**Pier 40 Structural Restoration – Phase 4
Invitation for Bids (IFB)
Project/Contract #C4874
Addendum No. 1
January 3, 2019**

ATTACHMENT A
SITE LOGISTICS PLAN
(SEPARATE ATTACHMENT)

ATTACHMENT B
AMENDMED AND RESTATED
SPECIFICATION 01140 – WORK RESTRICTIONS
(SEPARATE ATTACHMENT)

AMENDED AND RESTATED SHEET S502 – CONCRETE REPAIR SCHEDULE
(SEPARATE ATTACHMENT)

PLAN OF FINISHED FLOOR
F-2

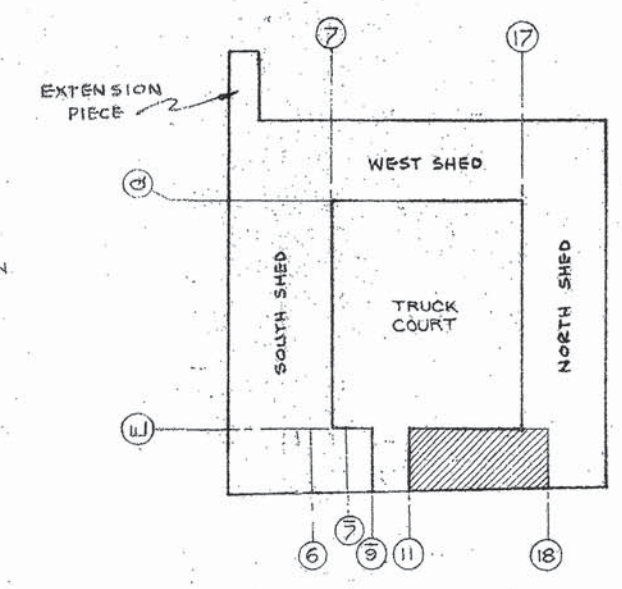
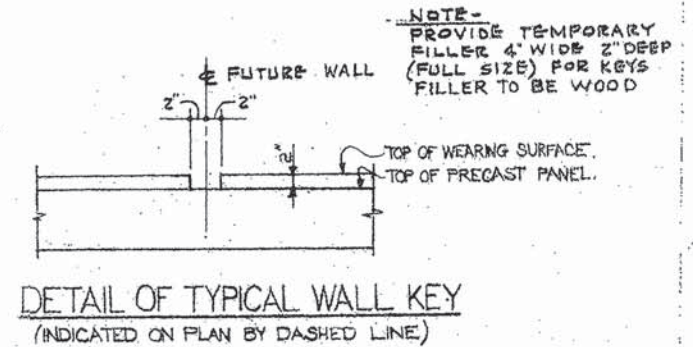
- MAXIMUM REAR AXLE/TANDUM AXLE LOAD OF 46 KIPS
- MAXIMUM REAR AXLE/TANDUM AXLE LOAD OF 34.5 KIPS
- ENTIRE PIER DECK RATED FOR A LIVE LOAD OF 100 PSF

PRESTRESSED PLANK AT COLUMN F9. MAXIMUM ALLOWABLE LIVE LOAD OF 100 PSF.
NO VEHICLE LOADING PERMITTED.

CONTRACTOR CAN CORE 8" DIAMETER HOLE THROUGH SLAB BETWEEN BENTS A AND A.
